ARCHITECTURAL DESIGN REPORT - ADDENDUM 01

Centre of Excellence in Agricultural Education

Richmond NSE

APPLICATION NO. SSD-1500146

Overall Roof Plan – Superseded (NTS)

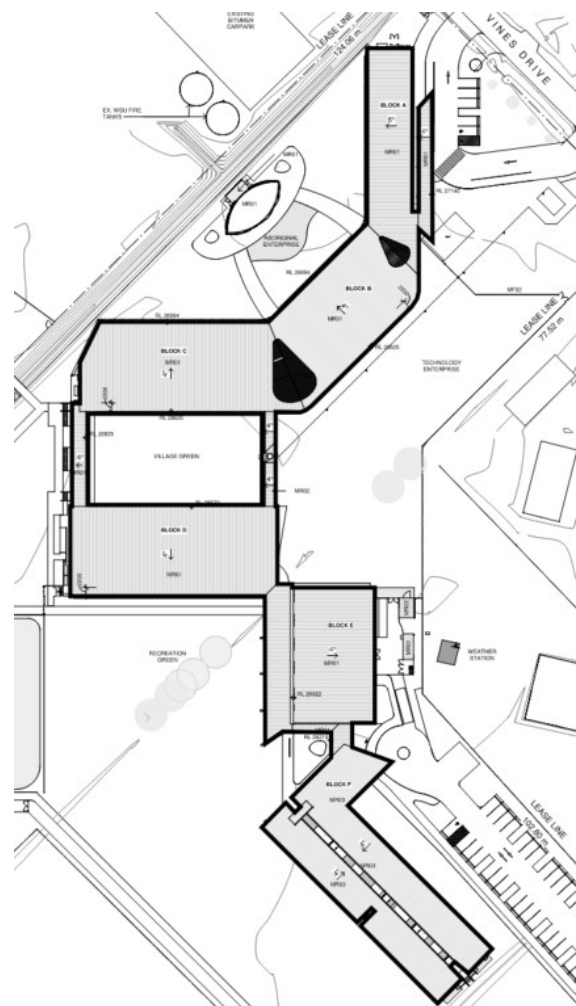
The area highlighted on the following drawing illustrates the extent of additions and reductions of roof area. This design rationalisation provides structural design efficiency for a more economical solution. The Main Entry Canopy located on the East of the Administration Block, Building A has been shifted further south to provide covered Public Entry to the Administration Entry of Building A.

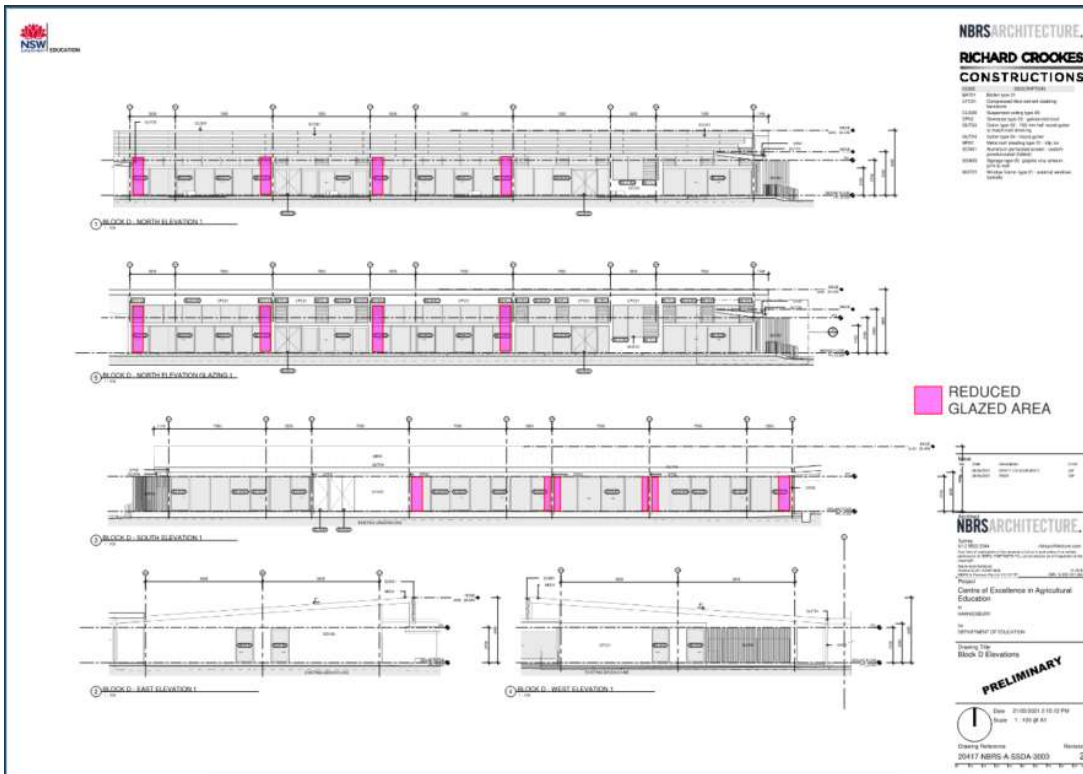
The three learning blocks, Building B, C and D, have received 15% reduction of the glazed area. This improves the overall structural design by providing additional structural support zones along the building facades. The following highlighted area of the building elevations illustrate the proportion of glazed façade that has been replaced with metal cladding with batt insulation.

It should be noted that the glazed area remains over and above the BCA requirement for daylight harvesting.

3.3 Accommodation Block, Building E

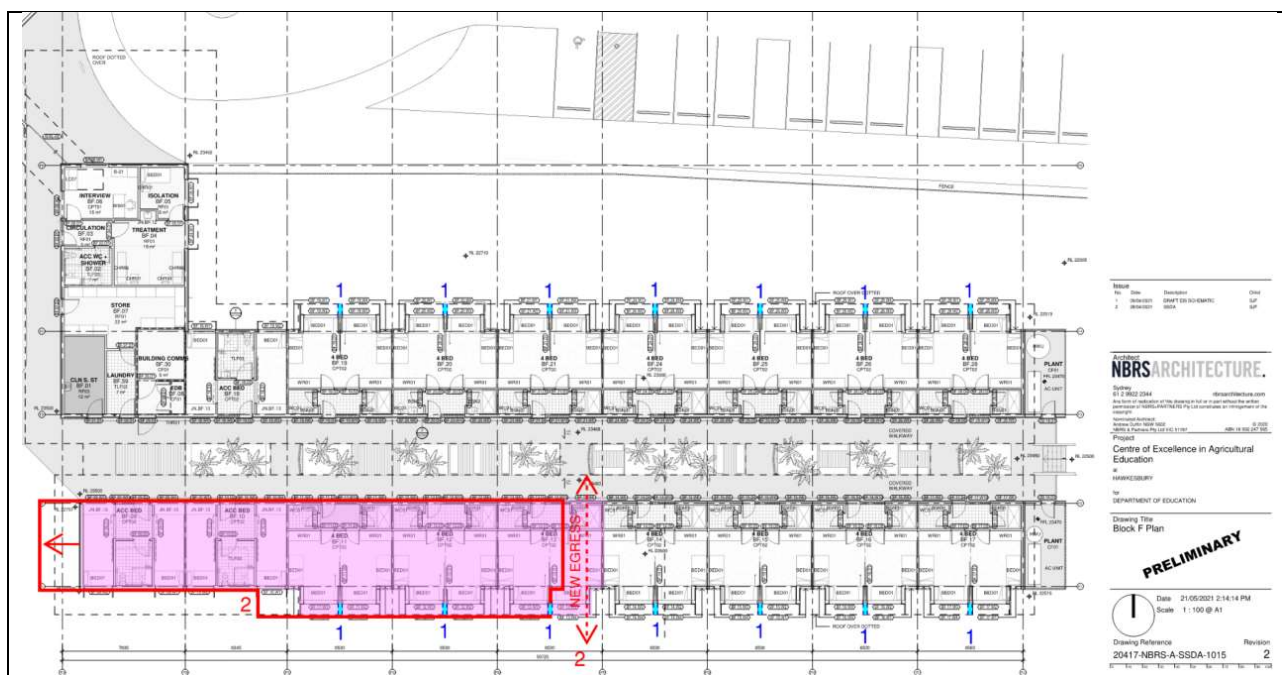
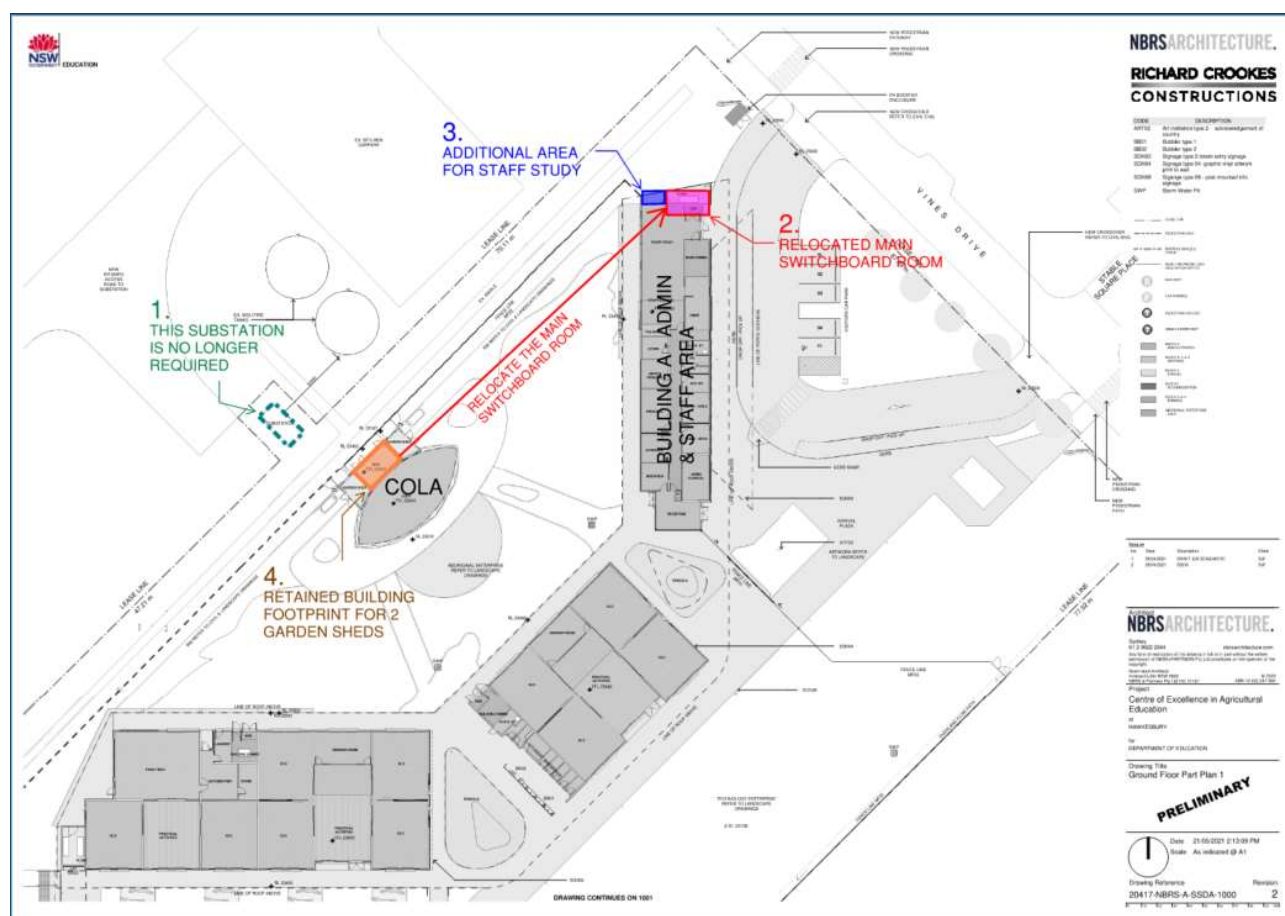
The following plan highlights two design changes which have resulted in the minor adjustment to the North & South Elevation of the building.

1. Design change 1 – Remove external protrusion of the recessed retractable doors as highlighted in light blue on the following drawing.
2. Design change 2 – Create an additional egress at mid-point of the southern portion of the Accommodation Block as highlighted in red lines & hatch on the following drawing.

- The new egress reduces the travel route to an open area from mid point of the building.
- The new egress path enables a direct access from the accommodation building to the open field located to the south of this building.

3.5 Minor Building Footprint Reduction - Building C & D

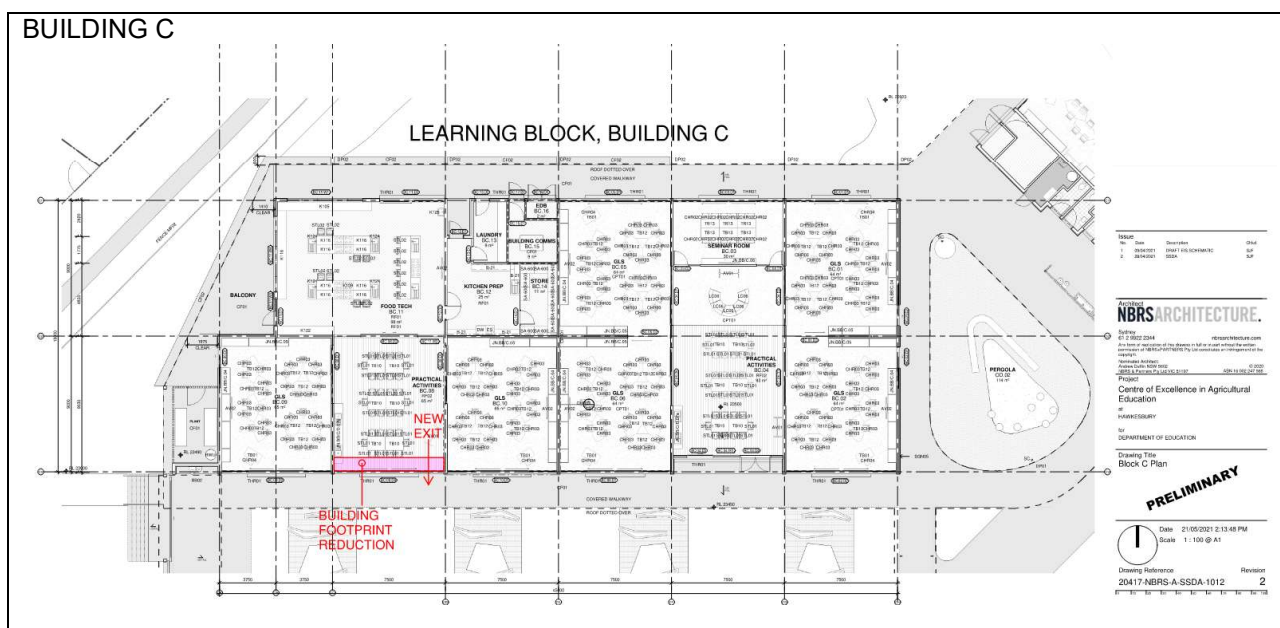
The following drawings illustrate the following minor changes to building C & D and how these changes improve the articulation of the respective building façade.

1. Additional recessed façade alters the south elevation of building C and south façade of building D
2. The functionality of the science area in building D will significantly improve by flipping the Botany/ Zoology with the neighbouring Practical Activity Area. This provides the opportunity for better daylight harvesting & ventilation into the Botany and Zoology.

- The recessed entry facade provides shorter egress path from the adjacent classrooms
- The recessed portion of a long single story building provides deeper external Foyer to the building entrances which subsequently improves the articulation to the building elevation.

Building G – Superseded layout

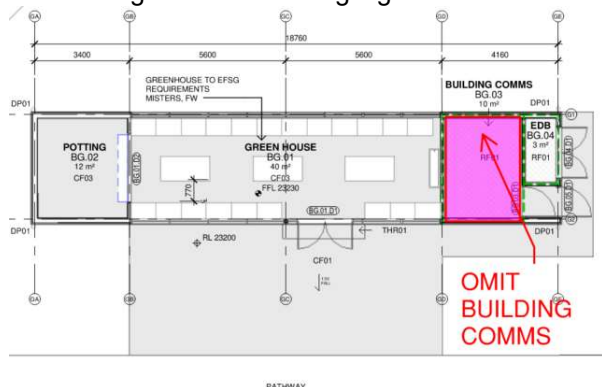
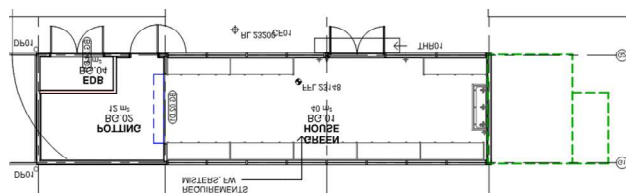
ICT services to building G is being connected to the nearby learning block, Building D. Thus, the footprint of building G has reduced by the depth of the building comms room highlighted below.

Building H - Superseded layout

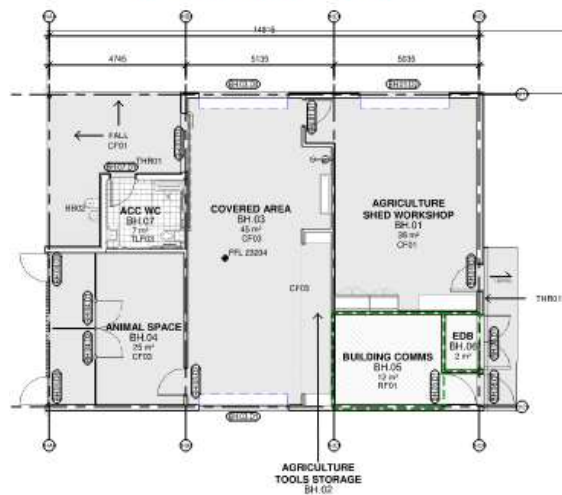
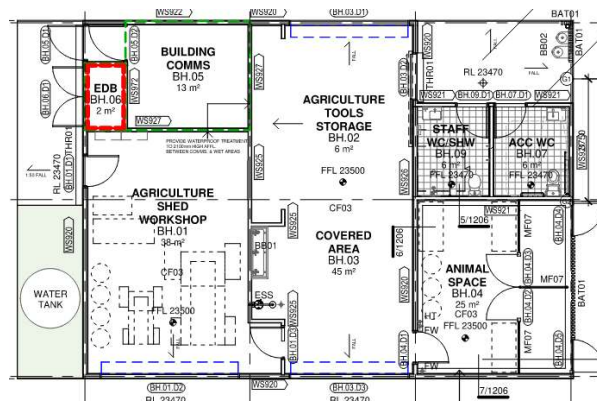
Flip
Add A staff WC & Shower

Building H is being flipped in East West direction to improve the connection and access from the main campus to the Covered Learning Area. Additionally, a dedicated staff WC & shower have been added to building H for use by the Farm Manager.

3.7 Agricultural Area

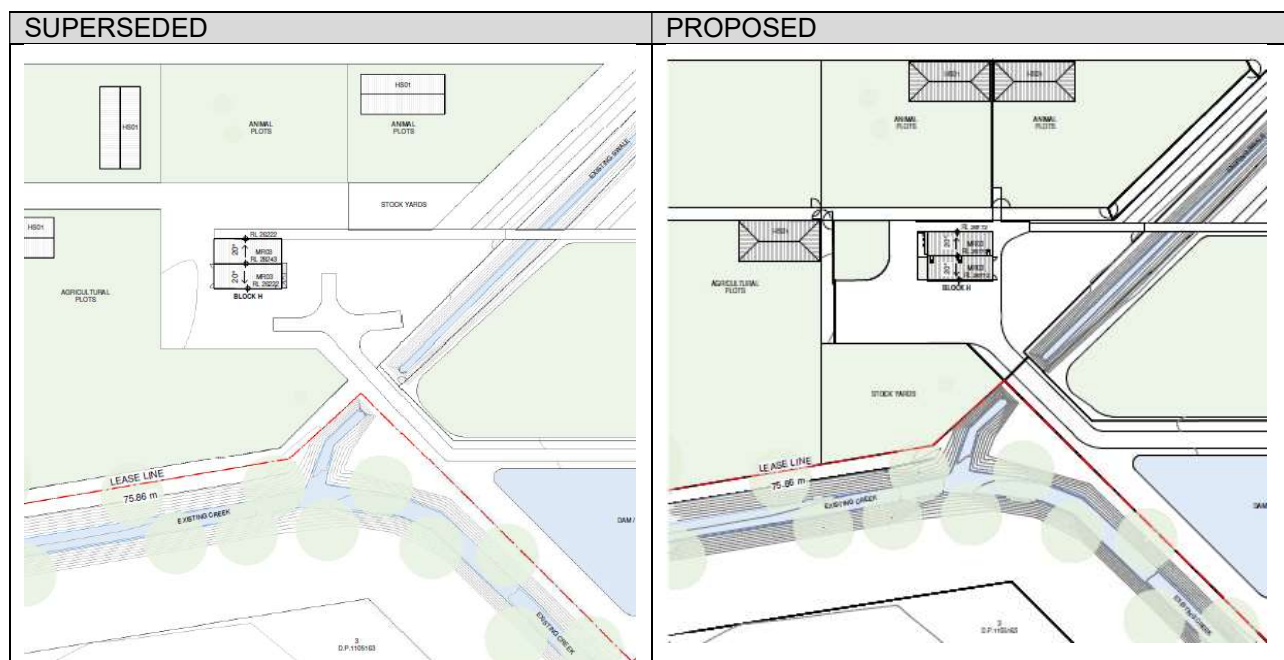
The following drawings illustrate the extent of planning amendments within the agricultural study areas. The following planning strategies have been considered:

- Reconfiguration of material drop off area to the south of building H to increase safety of students by restricting their access to the loading area
- The design reduces hardscape surface area so to increase agricultural plot area.
- Consolidate the location of animal sheds for ease of access from the adjoining building, links & paths

3.8 Services Area Adjacent to Hall

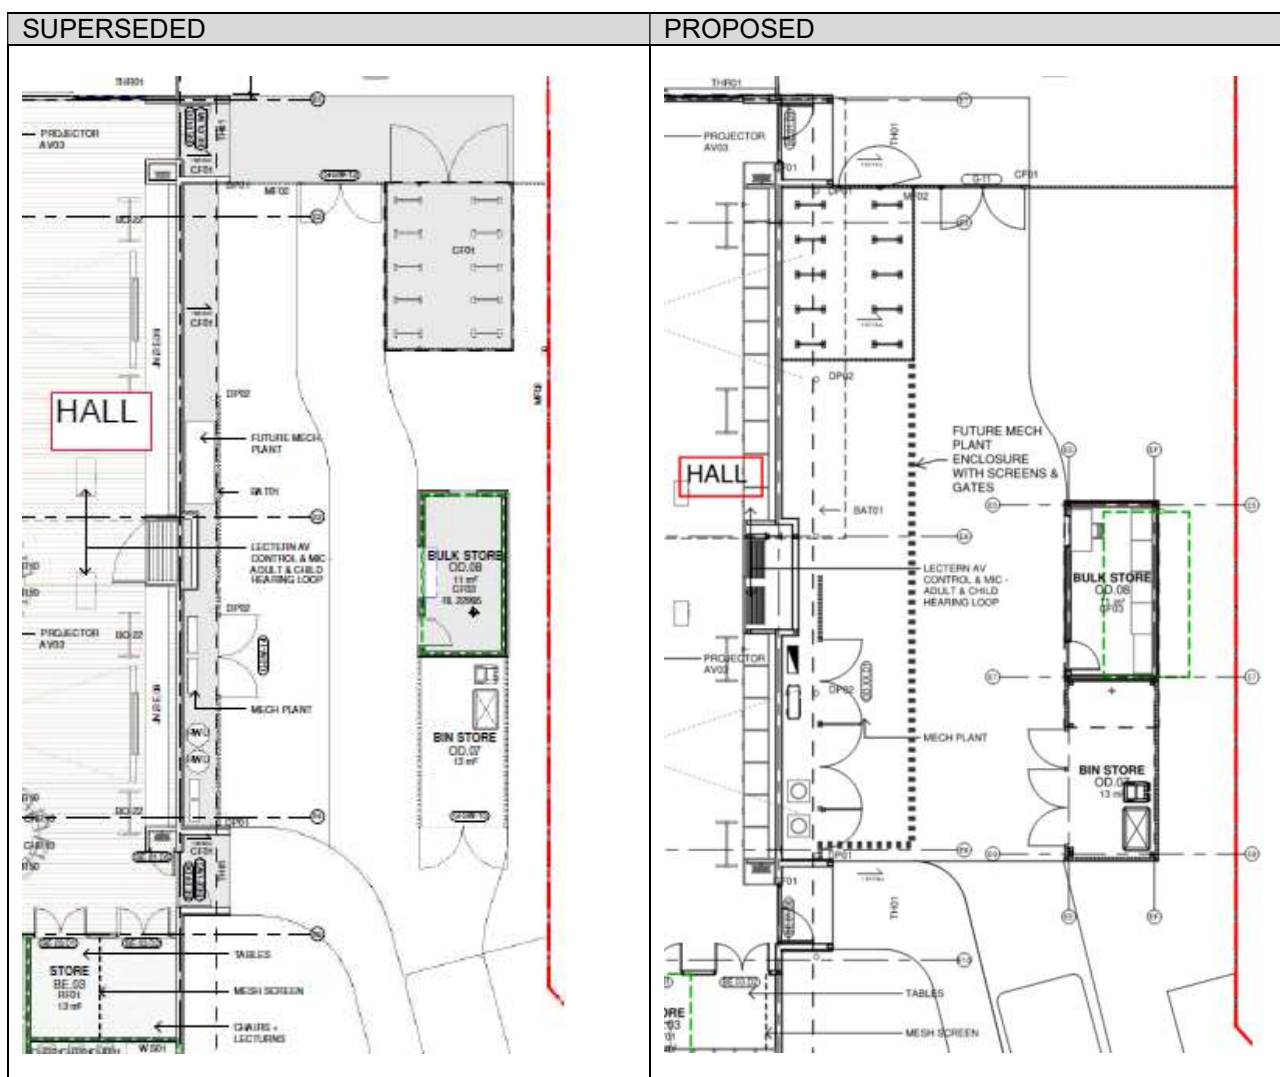
The following planning changes affecting the services areas adjacent to the Hall have been carried out:

- Relocation of bike enclosure and removal of bike shed. The bike park will be secured inside a fenced compound.
- The propose plan shows a redefine the area allocated to future mechanical plant. Mechanical plant will be concealed inside a well screened plant enclosure to match the bin enclosure screen.
- Gates for the bin enclosure are located on the west façade of the bin compound.

3.9 Services Vehicle Access

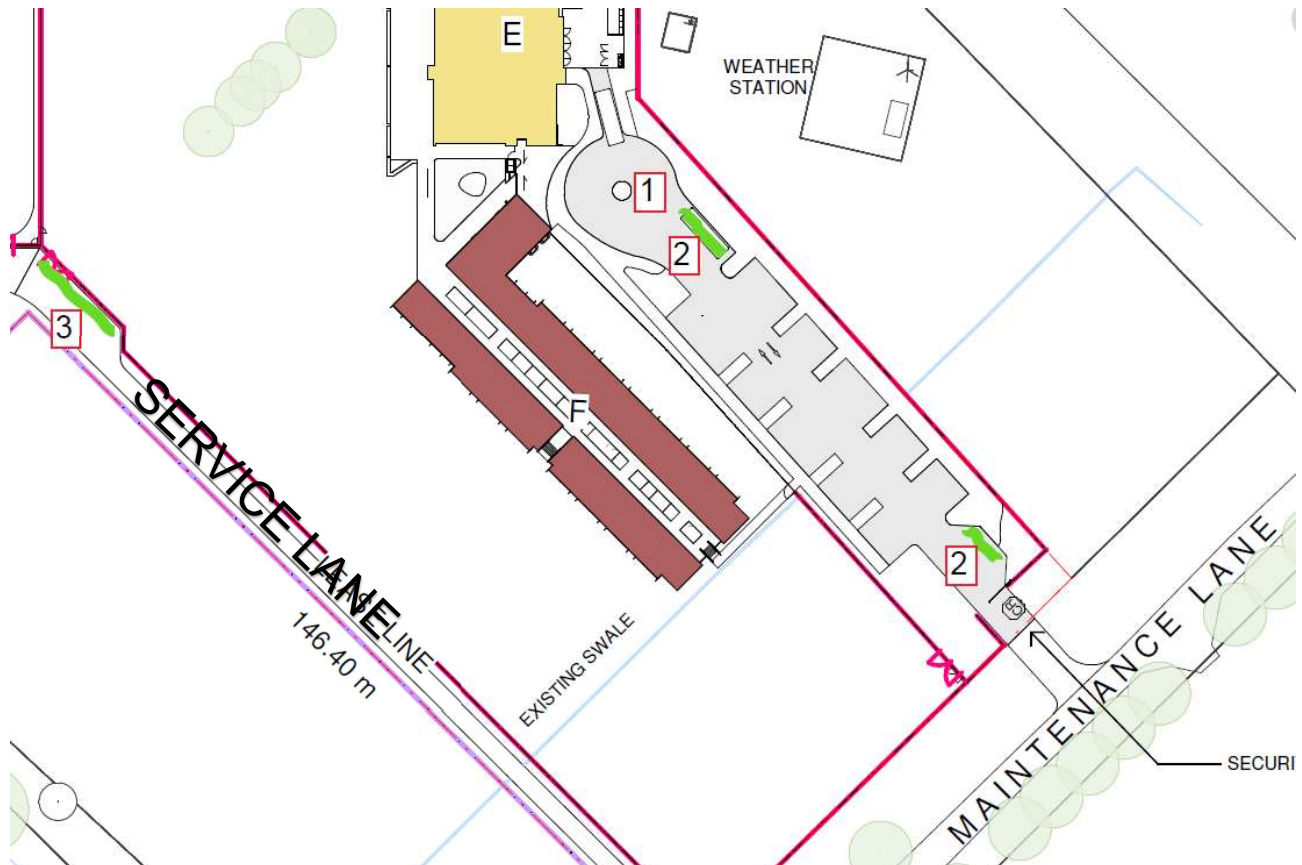
The following improvements have been made to the carpark and services vehicle access:

1. Increase the radius of internal vehicle turning area to accommodate a mini bus turning circle
2. Provide 2 mini buses parking spots
3. Provide a slip lane to improve services vehicle and fire truck turning along Service Lane.
